Architect's Supplemental Instructions

PROJECT: *(name and address)*
17-13 OSU College of Med. at Hastings
Tahlequah, OK

ASI INFORMATION:
ASI Number: Bid Package 03 - ASI 02
Date: 05-24-2019

Bid Package 03- ASI 02 – OSU College of Osteopathic Medicine At The Cherokee Nation

SHEET NUMBER:
S1.02
 BASEMENT FOUNDATION PLAN - SECTOR 2

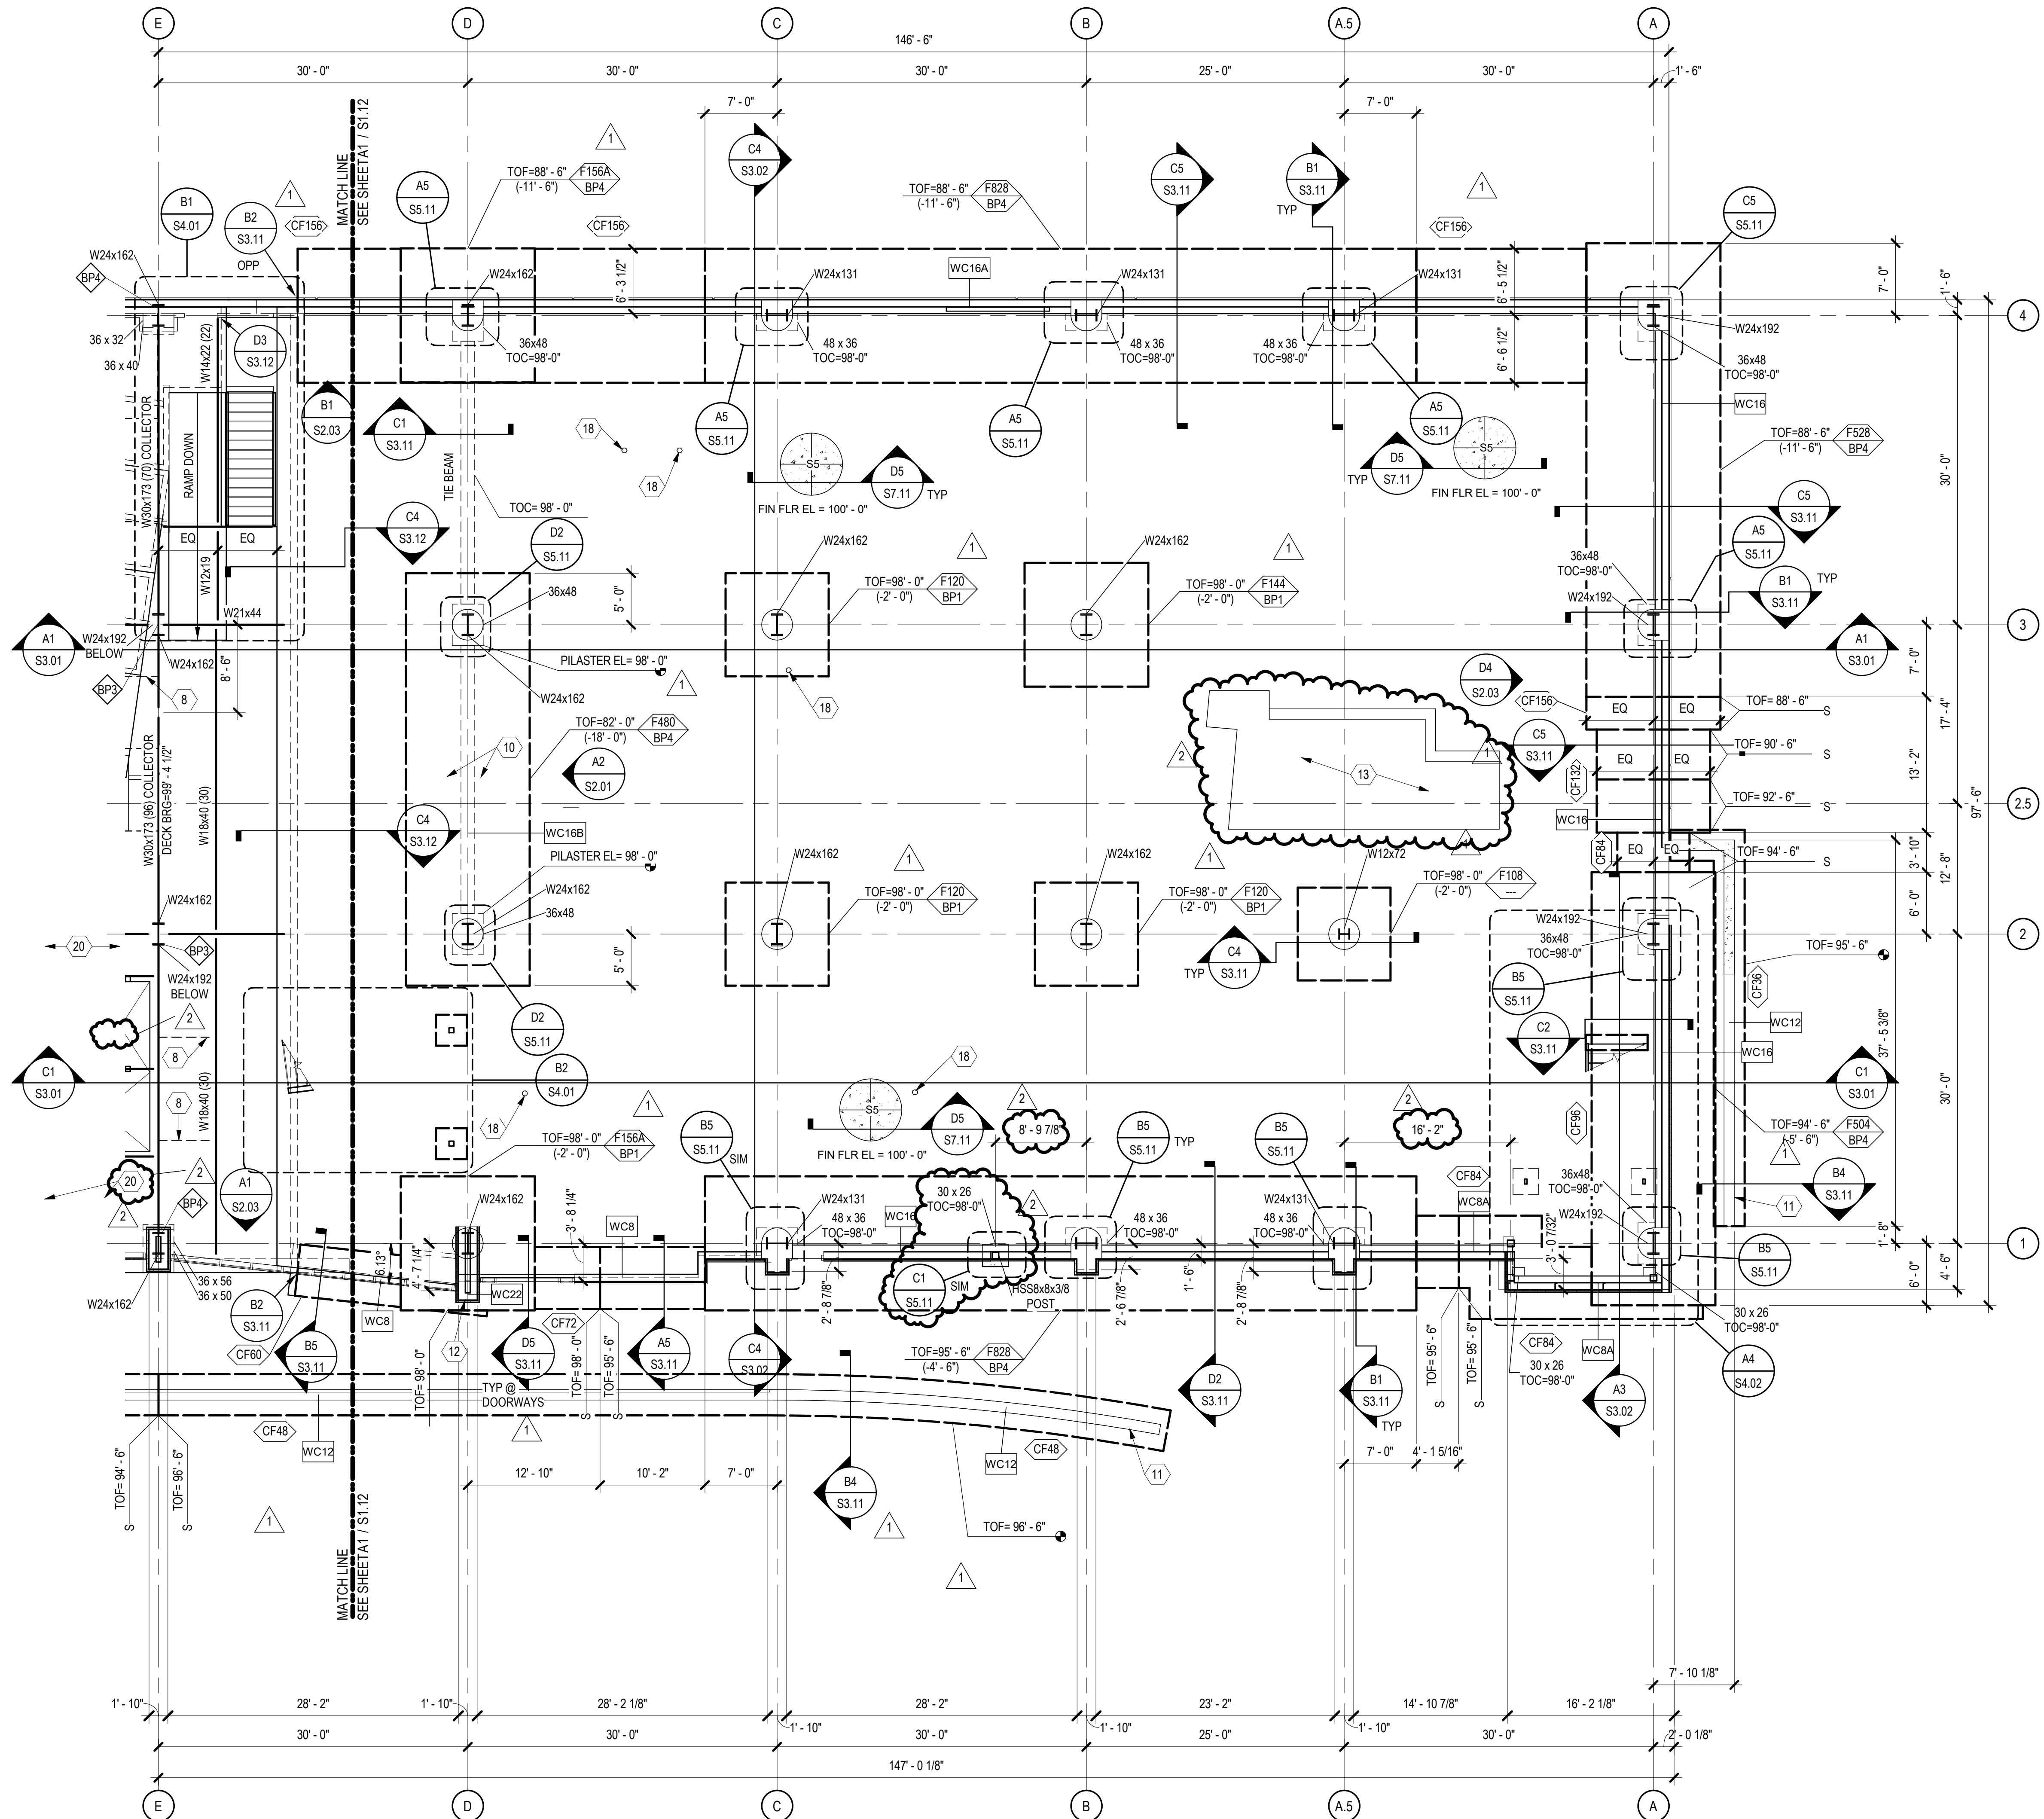
<u>Sheet</u>	<u>Description</u>
S1.02	Concrete screen wall and foundation added to plan, along Grid J, between Grid 1 and 2.5.
S1.02	Pedestals added to accommodate column furr outs at Grid J-1 and J-2.5.
S1.02	Footing elevation at Grid E-2 modified.
S1.02	Sheet keynotes 10 and 11 added.
S1.02	Sheet keynote 4 modified.
S1.11	Clarifying dimensions added to locate HSS posts along grid or near Grid 1.
S1.11	Pedestal added to support post near Grid B-1.
S1.11	Podium framing outline added near Grid A.5-2.5.
S1.11	Sheet keynote 13 added.
S1.12	Clarifying dimensions added to locate floor beams between Grids 1 and 2.
S1.12	Clarifying section A3/S3.12 added along Grid 1 at concrete wall.
S1.12	Cross bracing added to beams between Grids G and F, 2 and 4.
S1.12	Sheet keynotes 18, 19, and 20 added.
S2.01	Entire sheet revised.
S2.02	Entire sheet revised.
S3.01	Section C1 modified to include concrete screen wall.
S3.02	Section A3 added and Section A4 modified.

- CONCRETE SCREEN WALL TO SUPPORT PRE-MANUFACTURED CANOPY. PROVIDE #4 U-BARS @ 32" OC AT TOP OF WALL. WALL SHALL NOT ATTACH TO ANY PORTION OF STRUCTURE, INCLUDING STEEL COLUMNS OR STEEL BEAMS. SEE ARCHITECTURAL FOR ADDITIONAL INFORMATION NOT SHOWN.

- PEDESTAL UP TO EXTERIOR GRADE. SEE A1 / S3.12 AND ARCHITECTURAL FOR ADDITIONAL INFORMATION.

B5 PERIMETER FOUNDATION SECTION
SCALE: 3/4" = 1'-0"

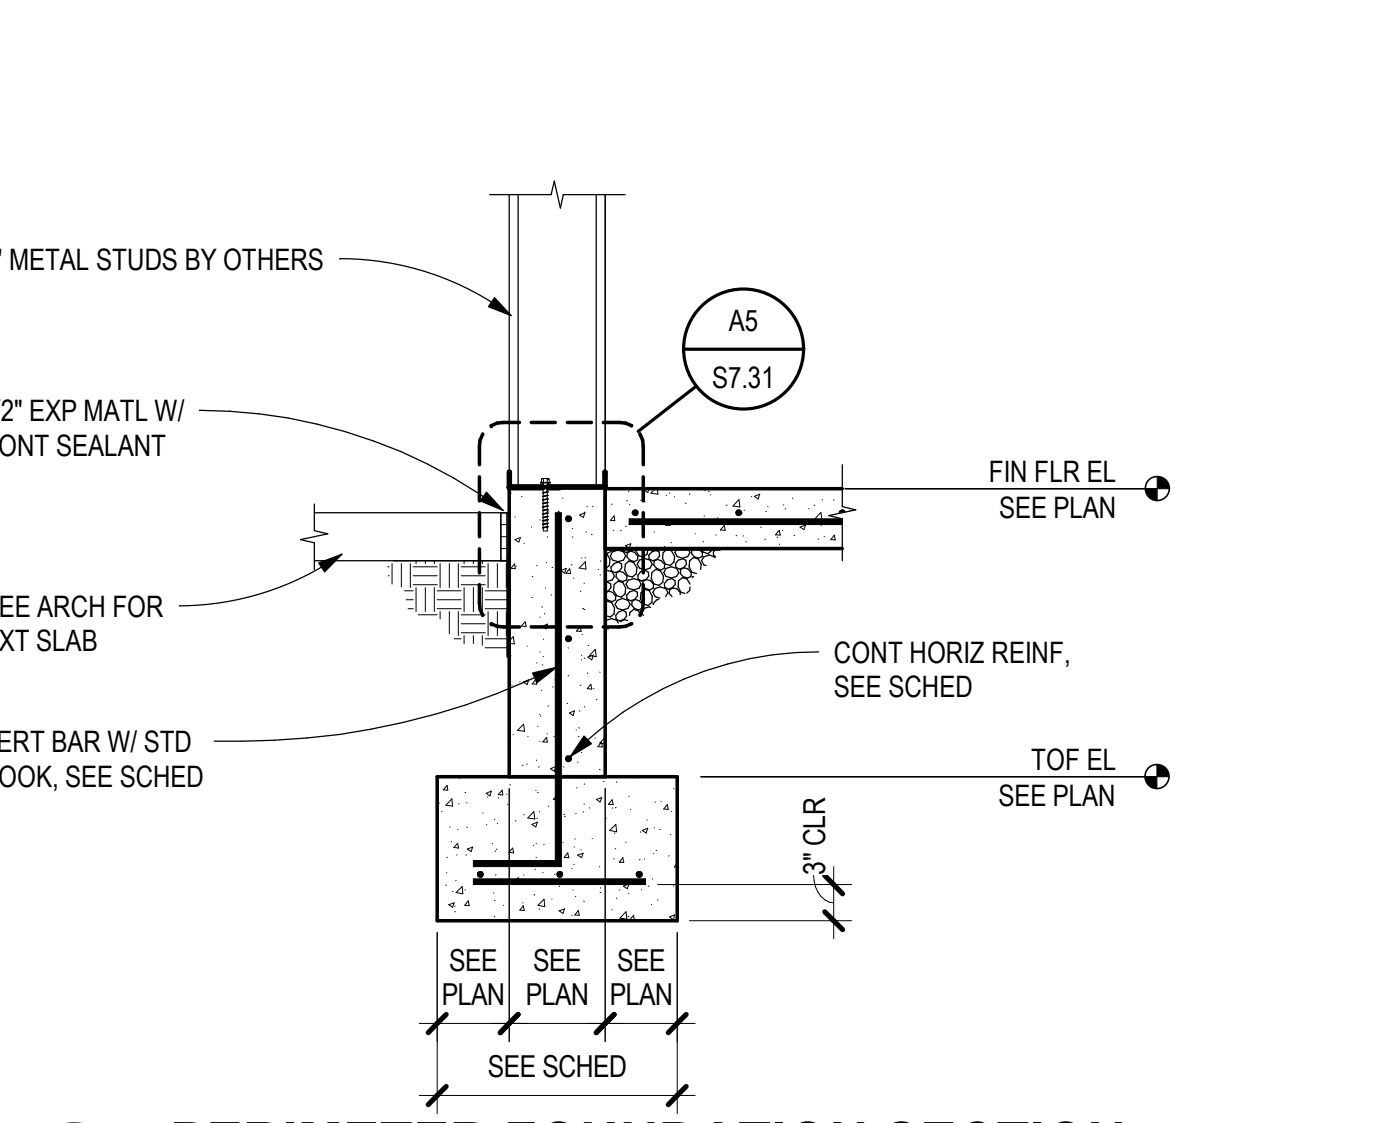
S3.11	Clarifying 'SIM' note added to section D3.
S3.11	Section B5 modified to accommodate raised glazing system.
S3.12	Section B2 added to accommodate raised glazing system.
S3.12	Section B3 modified to include additional beam sizes.
S3.12	Section A1 added to accommodate column furr outs.
S4.01	Entire sheet revised.
S4.02	Entire sheet revised.
S5.11	Clarifying 'SIM' note added to detail C1.
S6.01	Slab-on-grade schedule revised.
S6.01	Additional wall height added to schedule A1.
